## HISTORIC AND DESIGN REVIEW COMMISSION

March 20, 2019

**HDRC CASE NO:** 2019-094  
**ADDRESS:** 601 BURNET ST  
**LEGAL DESCRIPTION:** NCB 538 BLK 22 LOT S 77.8 FT OF W 55.53 FT OF 8  
**ZONING:** R-4, H  
**CITY COUNCIL DIST.:** 2  
**DISTRICT:** Dignowity Hill Historic District  
**APPLICANT:** Milena Stepanovic  
**OWNER:** Terminal Gravity LLC  
**TYPE OF WORK:** Porch and Window Repairs (Post-work approval)  
**APPLICATION RECEIVED:** February 20, 2019  
**60-DAY REVIEW:** April 19, 2019  
**REQUEST:**

1. Cover an existing front concrete porch with a wood porch under the existing roofline, and
2. Replace non-original square windows with custom single-hung wood windows.

CURRENT PHOTO  
PER APPLICANT  
OF PORCH

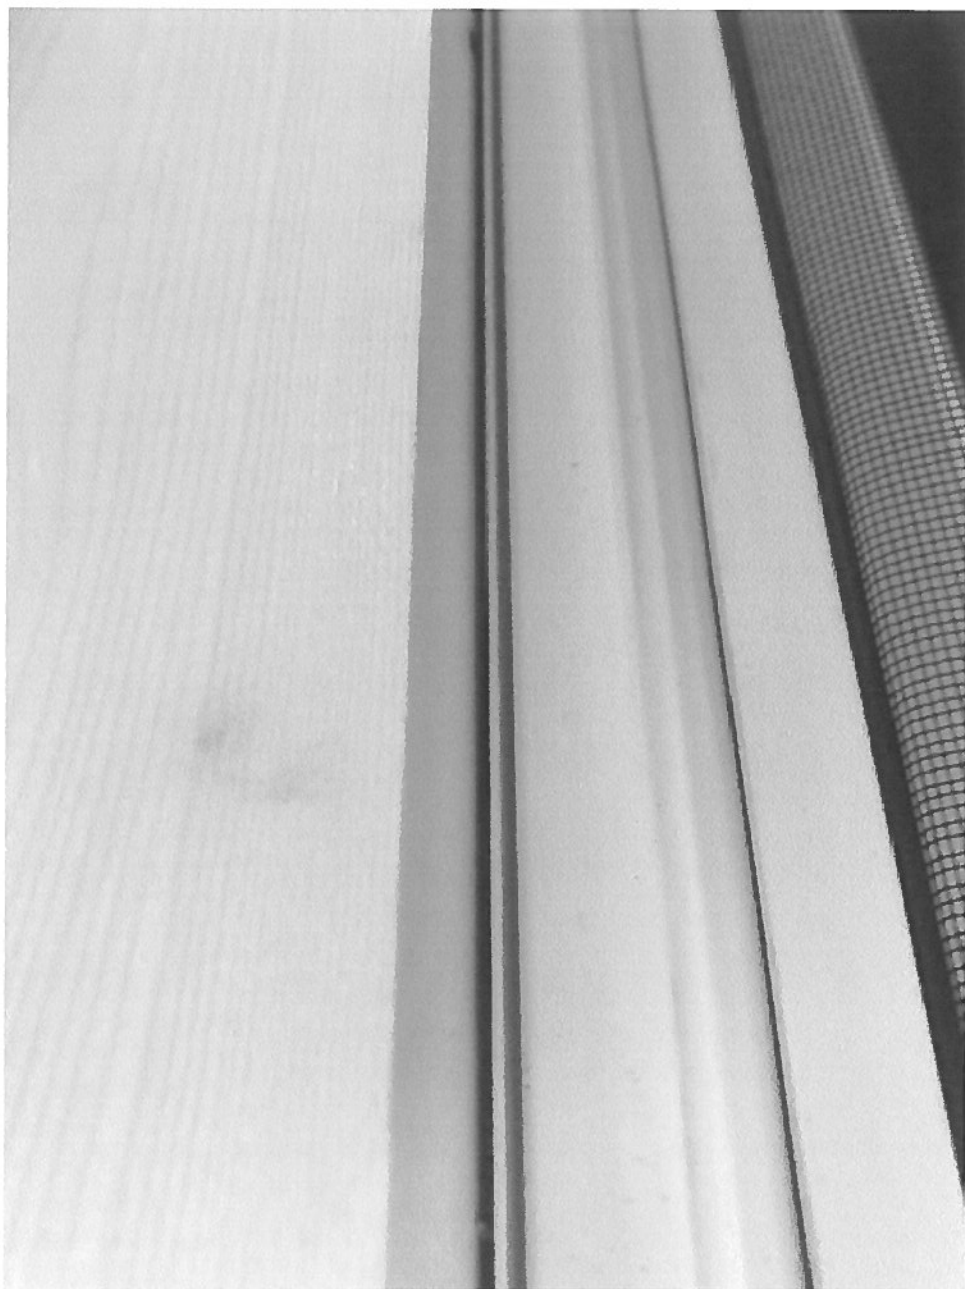
- c. PORCH – The applicant has proposed to install wood decking and new wood columns and railing with lattice skirting on the existing concrete porch. Per the Guidelines for Exterior Alterations and Modifications 7.B.v., the reconstruction of porches should be based on accurate evidence of the original, such as photographs. If no such evidence exists, the design should be based on the architectural style of the building and historic patterns. Staff finds that the concrete porch and wrought iron columns are not original to the structure and may be replaced or covered with a wood porch configuration based on historic evidence. The applicant submitted a design featuring three square columns and a pilaster. Staff finds that porches of this size and in the Folk Victorian style would only feature two full columns. Additionally, staff finds the proposed lattice skirting should instead feature Hardie or lap siding in a configuration that matches the historic profile of a wood deck. All porch elements including the decking, columns, railing, and skirting should feature a simplified historic profile and configuration.

Staff recommends approval of porch reconstruction based on finding c with the following stipulations:

- i. The porch should feature tongue-and-groove decking featuring members that are approximately 3 inches wide and 1 inch tall to be installed perpendicular to the front wall.
- ii. The porch should feature only two full columns, one at the corner and one adjacent to the porch steps.
- iii. Porch skirting should feature a wood or Hardie siding matching the historic structure; faux wood grain texture or lattice skirting should not be used.

601 BURNET ST FRONT ELEVATION

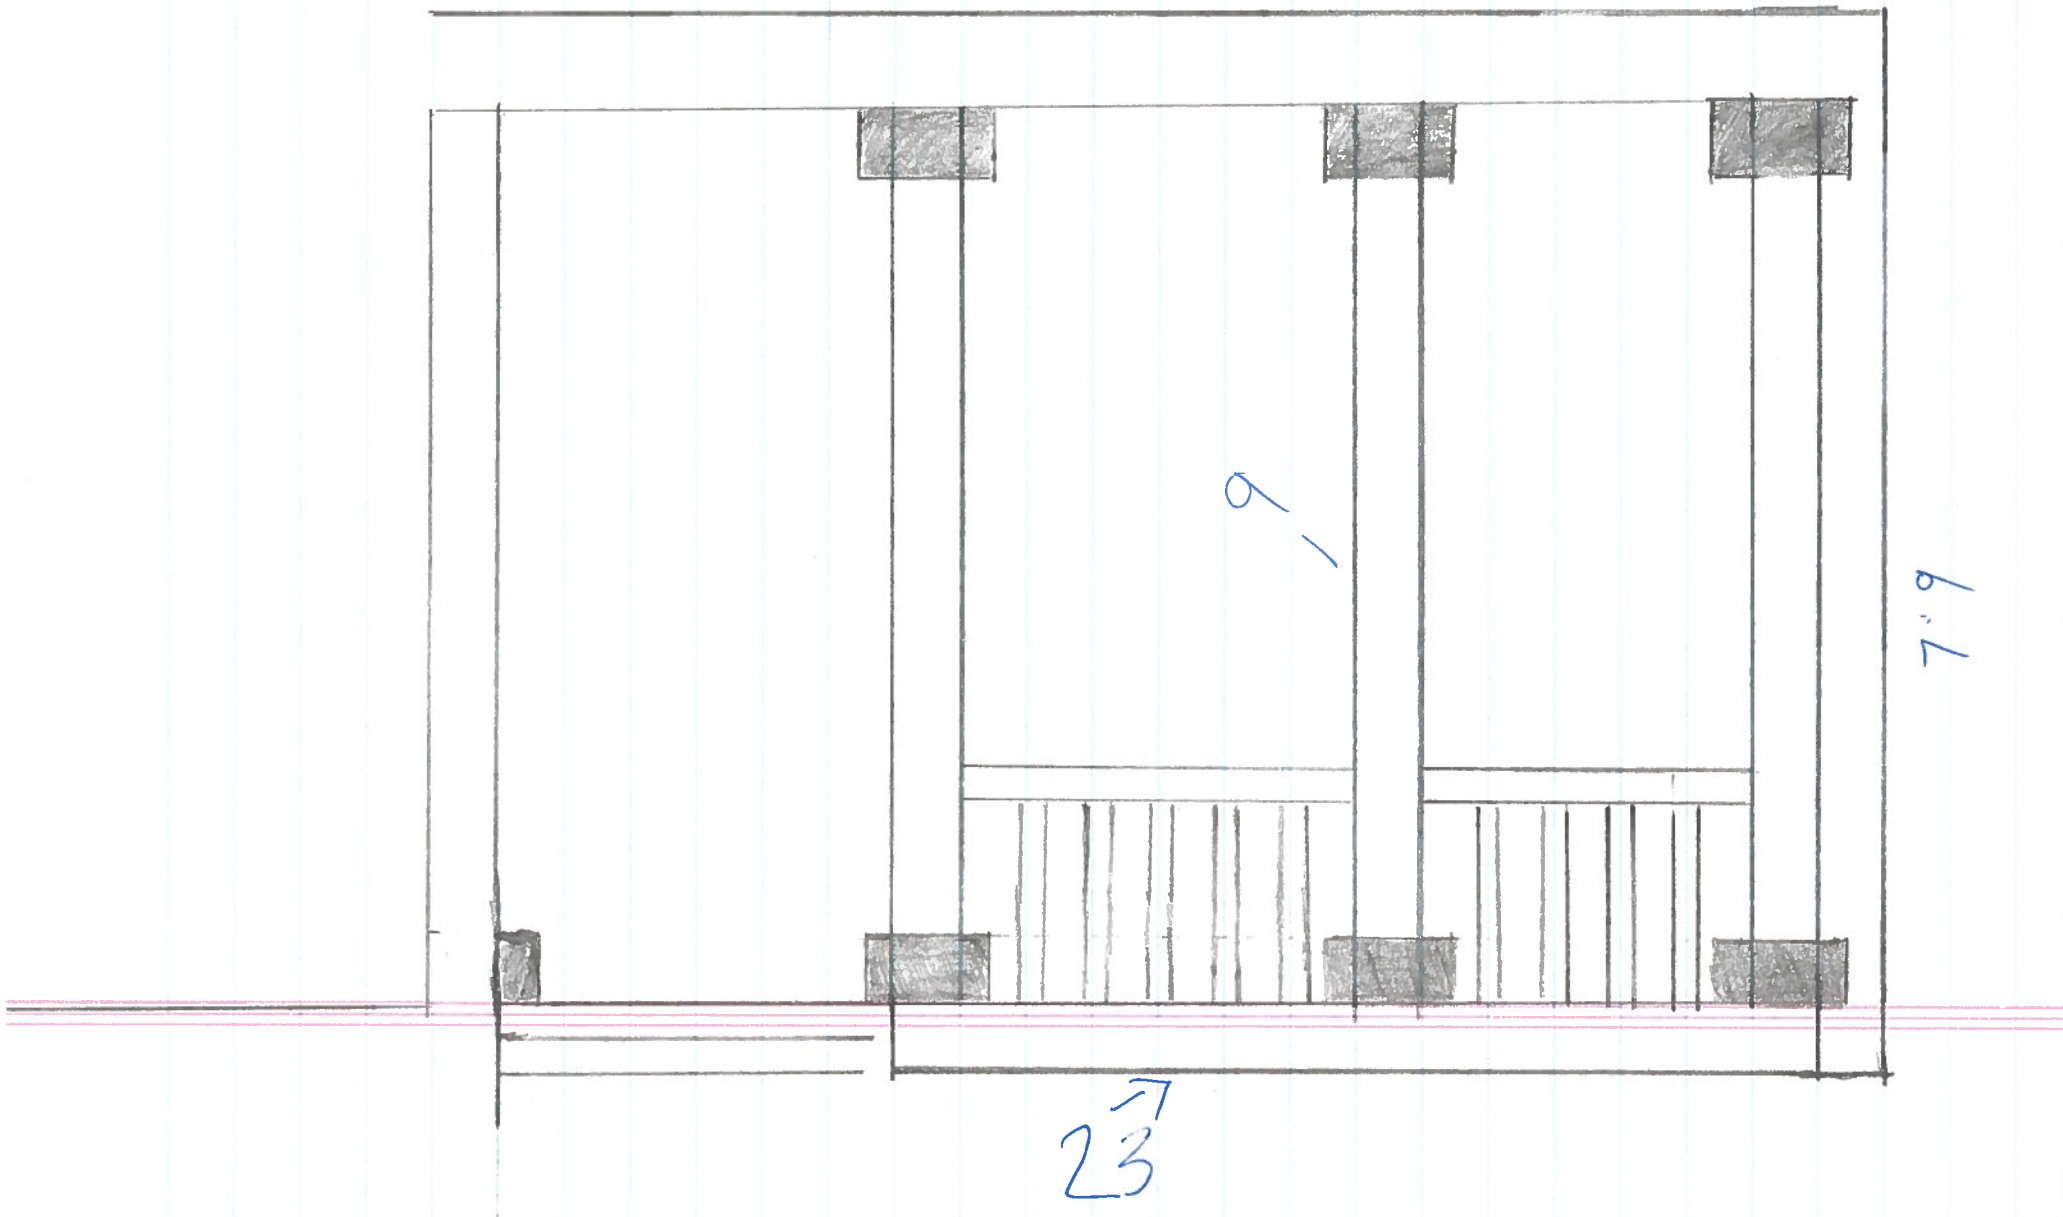
- d. EXISTING WINDOWS – The property from at least 1994 to 2018 featured square windows with faux shutters. These windows are not original to the structure which would have historically featured wood, sashed windows. Staff finds that window replacement with restoration to window opening dimensions and trim would be an improvement to the historic structure.

- i. NEW WINDOWS – The applicant has proposed to install one-over-one wood sashed windows. Per the Guidelines for Exterior Modifications and Alterations 6.B.vii., non-historic incompatible windows should be replaced with windows that are typical of the architectural style of the building. Staff finds that the proposed windows are generally appropriate and should meet the standard specifications for new windows: *Meeting rails that are no taller than 1.25" and stiles no wider than 2.25". White manufacturer's color is not allowed, and color selection must be presented to staff. There should be a minimum of two inches in depth between the front face of the window trim and the front face of the top window sash. This must be accomplished by recessing the window sufficiently within the opening or with the installation of additional window trim to add thickness. Window trim must feature traditional dimensions and an architecturally appropriate sill detail. Window track components must be painted to match the window trim or concealed by a wood window screen set within the opening.* New window trim should feature a dimension and configuration that matches the pattern of the historic structure within the district.

Staff recommends approval of window replacement based on findings d and e with the following stipulations:

- ii. New windows should feature the standard specifications: *Meeting rails that are no taller than 1.25" and stiles no*

*wider than 2.25". White manufacturer's color is not allowed, and color selection must be presented to staff. There should be a minimum of two inches in depth between the front face of the window trim and the front face of the top window sash. This must be accomplished by recessing the window sufficiently within the opening or with the installation of additional window trim to add thickness. Window trim must feature traditional dimensions and an architecturally appropriate sill detail. Window track components must be painted to match the window trim or concealed by a wood window screen set within the opening.*

- iii. New window trim should feature a dimension and configuration that matches the pattern of the historic structure within the district.
